Office Action Summary

10/006,621

TAKAOKA, HIDEYUKI

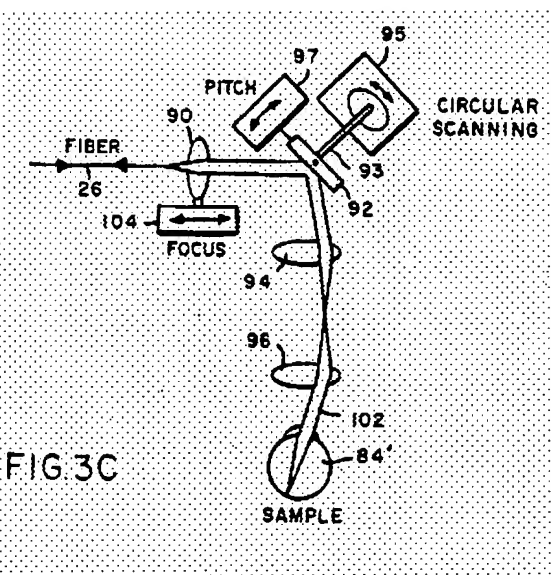
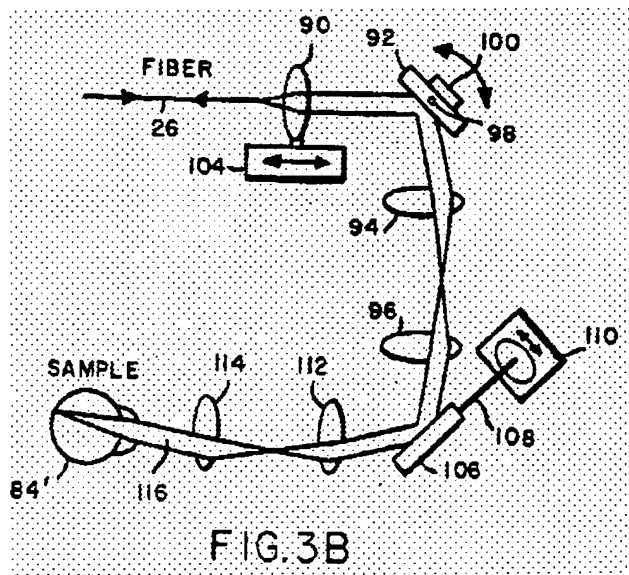
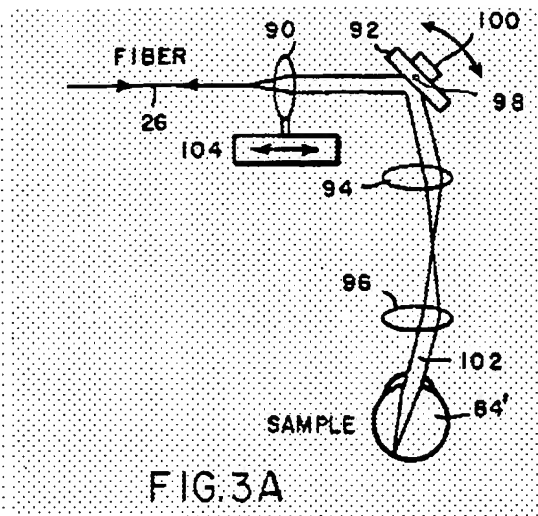
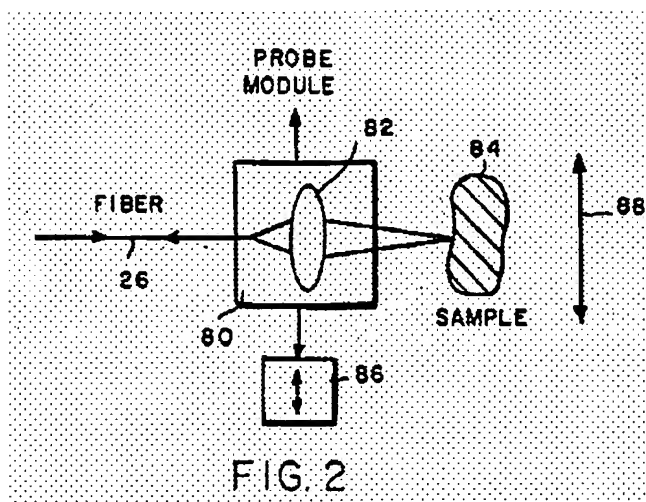
Claims 1, 2, and 5 are rejected under 35 U.S.C. § 102(b) as being clearly anticipated by Swanson et al(5,321,501).

Swanson teaches a coherence domain reflectometer comprising a short coherence light source(12); fiber coupler(22); a reference arm which includes AOM's(36,40), a path length scanner(42,46), and reference mirror(44); a measurement arm which includes a PZT phase modulator(34), and scan

mechanism(28); and photodetector(52). See figure 1A. Fiber/lens combinations change the diameter of the measurement beam. Also taught are multiple scanning arrangements including 1-3 dimensional scanning. See figures 2-3c. Figures 3a-4b also include pupil relays.

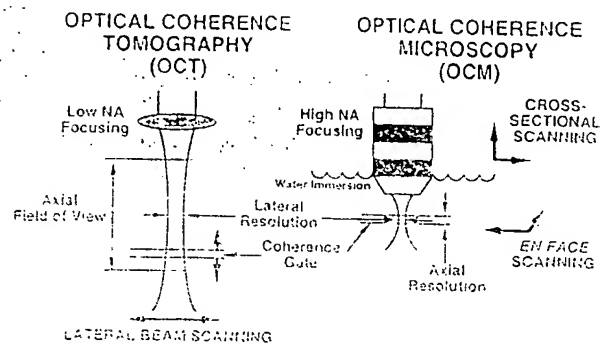
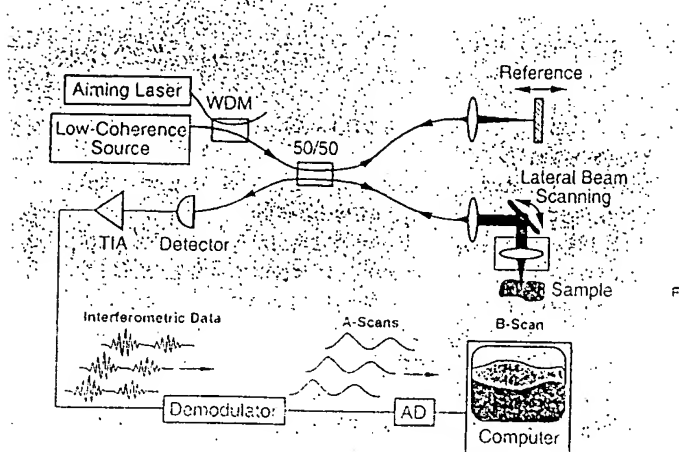
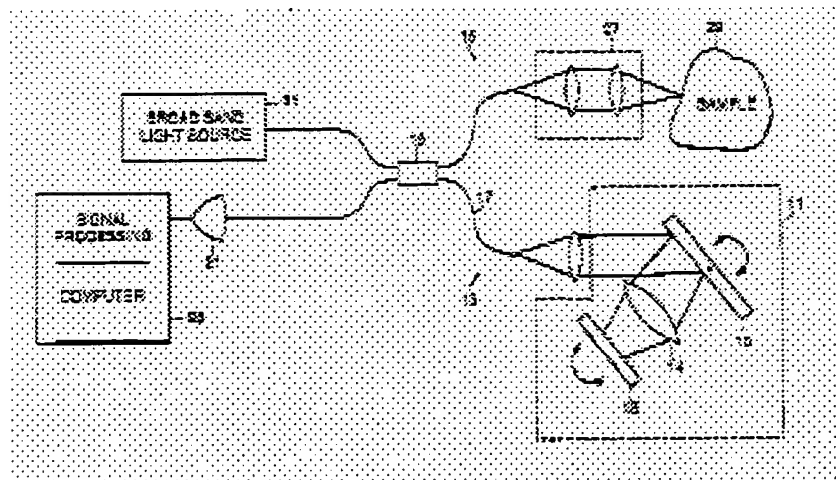
Claims 6-15, 17, and 19 are rejected under 35 U.S.C. § 103(a) as being unpatentable over Swanson et al(5,321,501) as applied to claims 3 and 4 above, and further in view of Izatt et al(Optics Letters).

Izatt et al teach that a low NA focusing objective can be used for OCT applications while a high NA focusing objective is used for OCM applications in a coherence domain reflectometer. See figures 1a and 1b.

It would have been obvious to one of ordinary skill in the art at the time the invention was made to use either a low NA or high NA focusing objective dependent on the application needed OCT or OCM.
